Re: Minor Project Refinement No. 7 for the TL 6975 San Marcos to Escondido Project.

TL6975 San Marcos to Escondido 69 kV Project CPUC Minor Project Refinement Form

Report No.: 7

MPR-7 Figure 1
Mapbook
San Diego County, CA

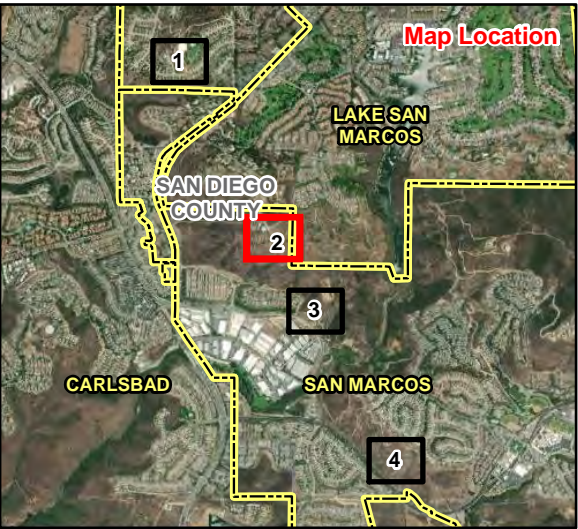
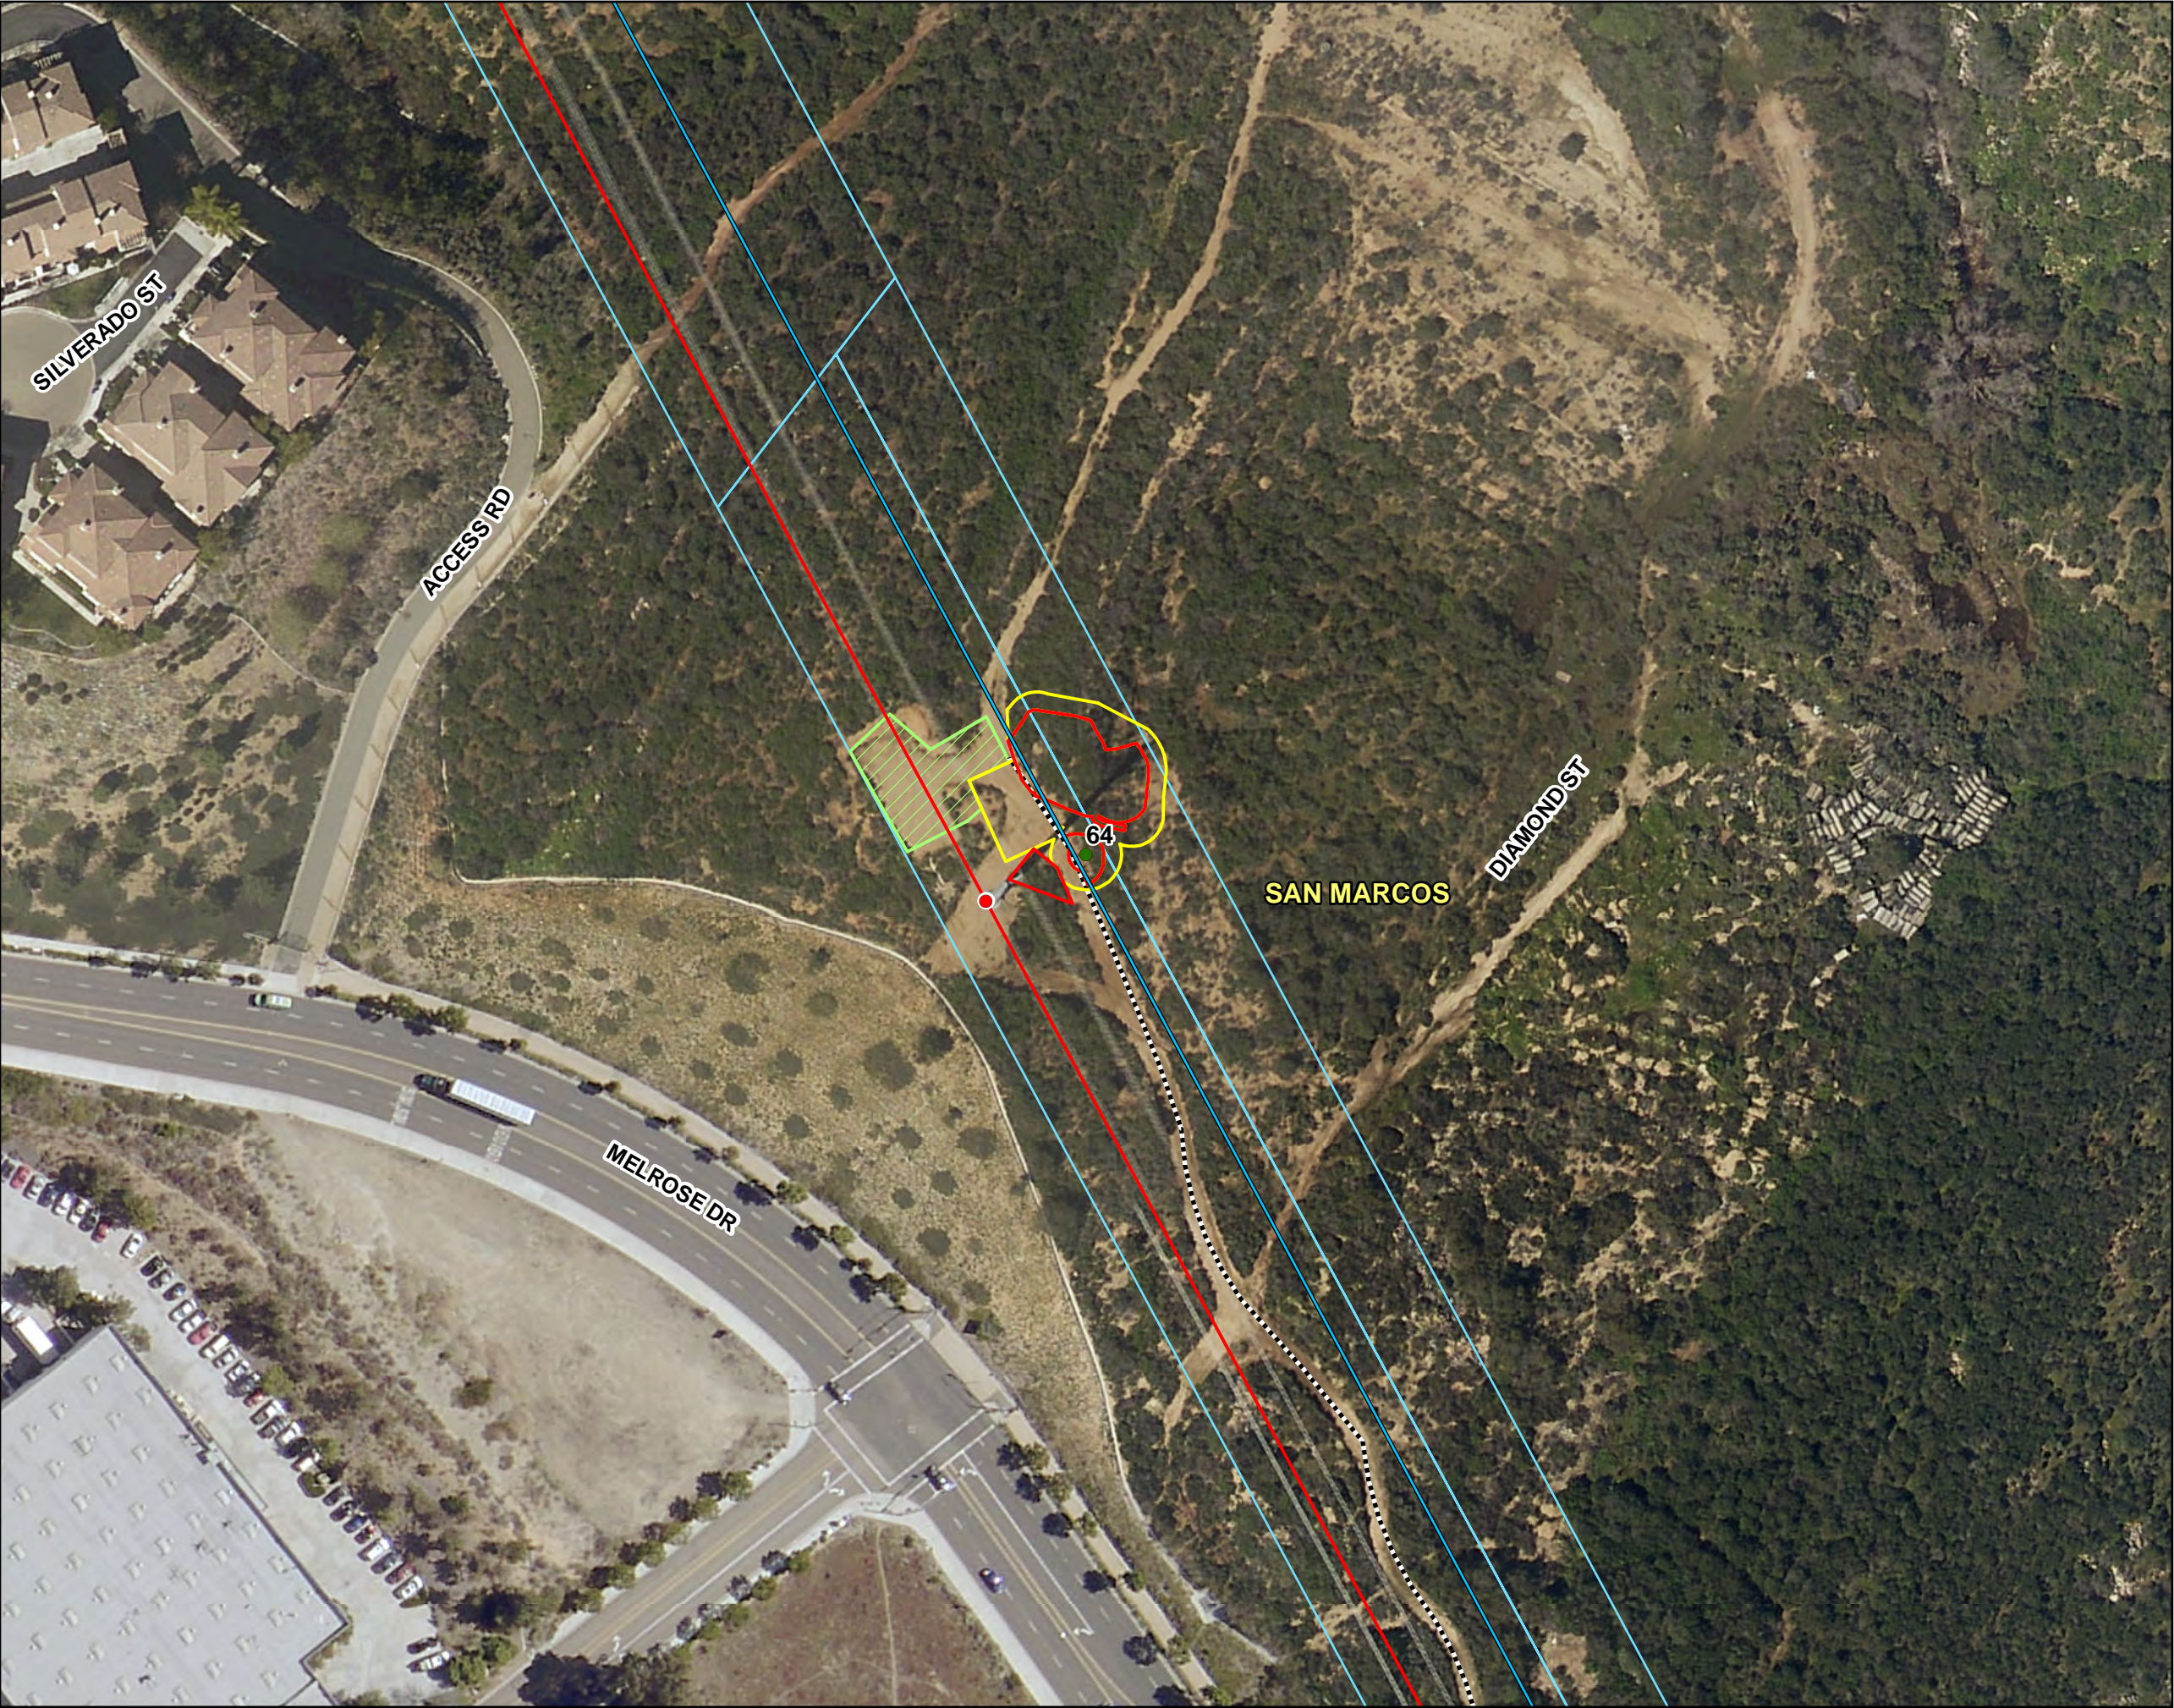
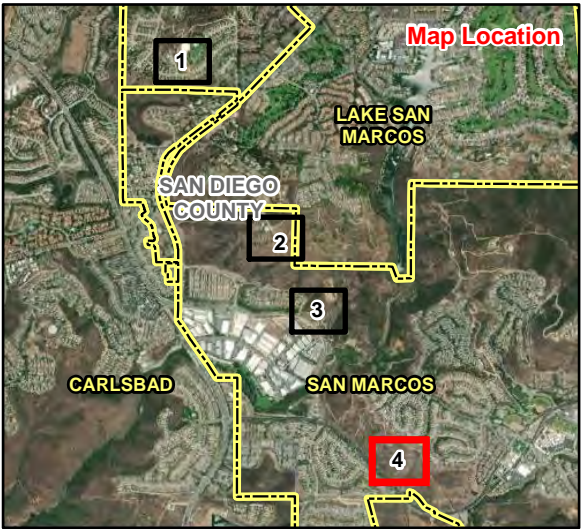
San Diego Gas and Electric (SDG&E) is requesting approval of MPR-7 for five additional temporary work areas (WA) at Locations 57, 62, 63, 64 and 69 to facilitate pole installation activities in Segment 2 of the TL6975 San Marcos to Escondido Project (Project). The additional work areas will be used for temporary staging of materials and equipment associated with the

Following the field constructability review, the construction contractor identified the need to utilize additional space for pier foundation pole installation activities at Locations 57, 62, 63, 64 and 69. In an effort to maximize available space to safely and efficiently perform the pier foundation pole installations while minimizing additional impacts resulting from the Project, MPR-7 is proposing the use of existing maintenance pads and previously disturbed areas to support this work (see **Attachment C, MPR-7 Site Photographs**). The MPR-7 additional work areas would be utilized for temporary staging of materials and equipment such as drill support equipment, water trucks for dust control, rebar cages, etc. In addition, the MPR-7 work areas can be used for safely maneuvering vehicles during pier foundation pole installation activities, such as turn-around areas for cement trucks.

Photograph 4:

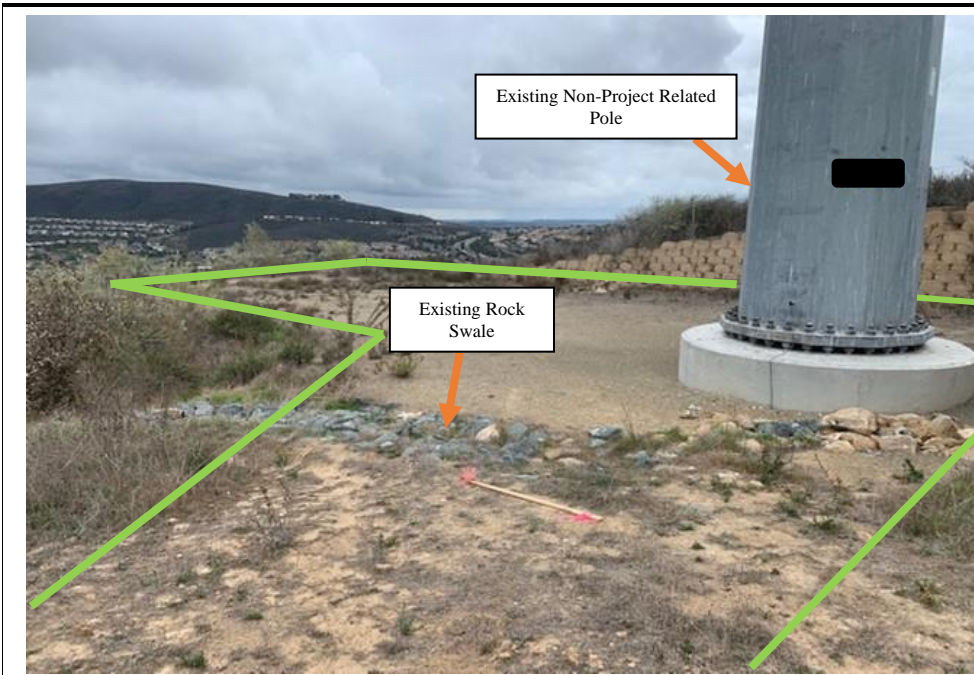
View of the requested WA 62 in green. Part of this work area is within an existing pad for a non-Project related pole. The access road is shown with arrows. Facing: S
